U.S. Department
of Transportation
**Federal Highway
Administration**

Refer to: HNG-14

**BARRIER GATE SYSTEM
SITE LAYOUT**

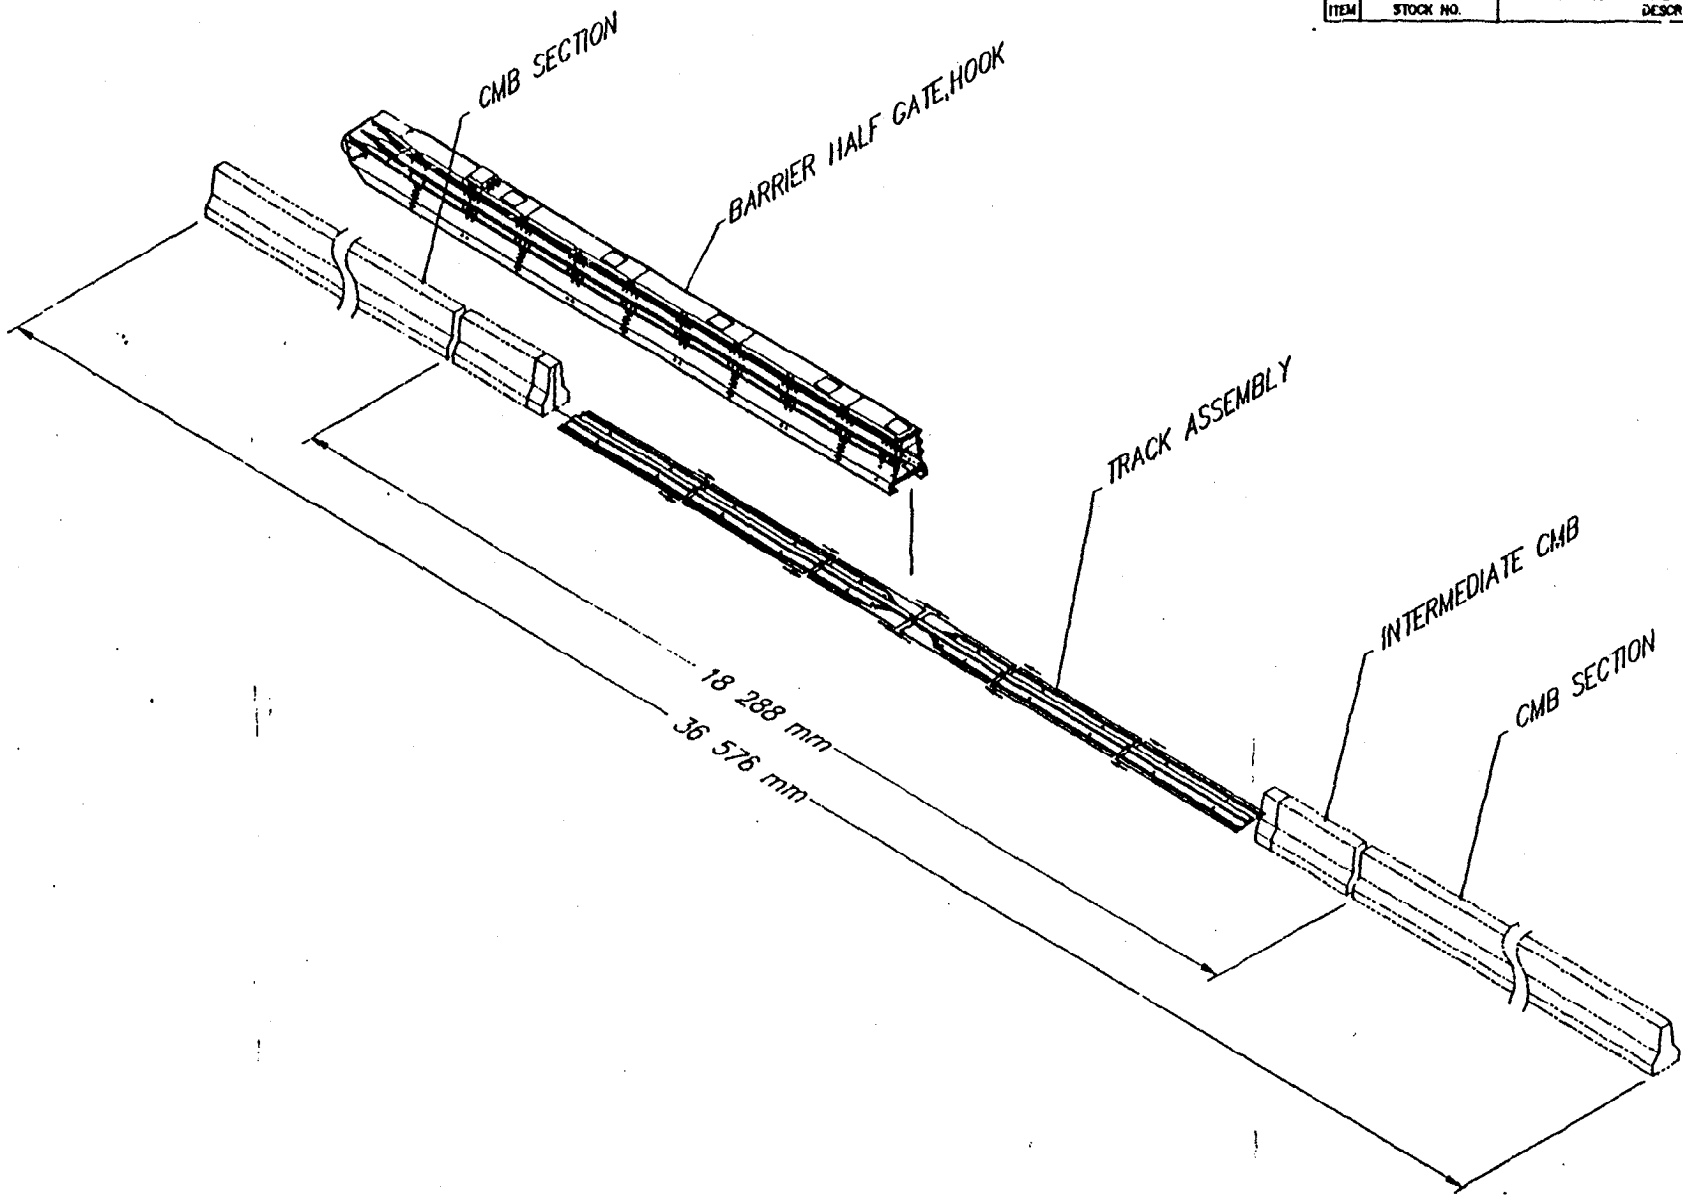
We noted in both 25 degree tests that the dynamic deflection of the barrier was approximately one meter. It is also apparent that the BarrierGate has a lower ultimate performance limit than the concrete safety shape in which it is used. These may be a factors to consider at locations where high-speed, high-angle impacts are likely and where commercial trucks constitute a significant percentage of the traffic stream.
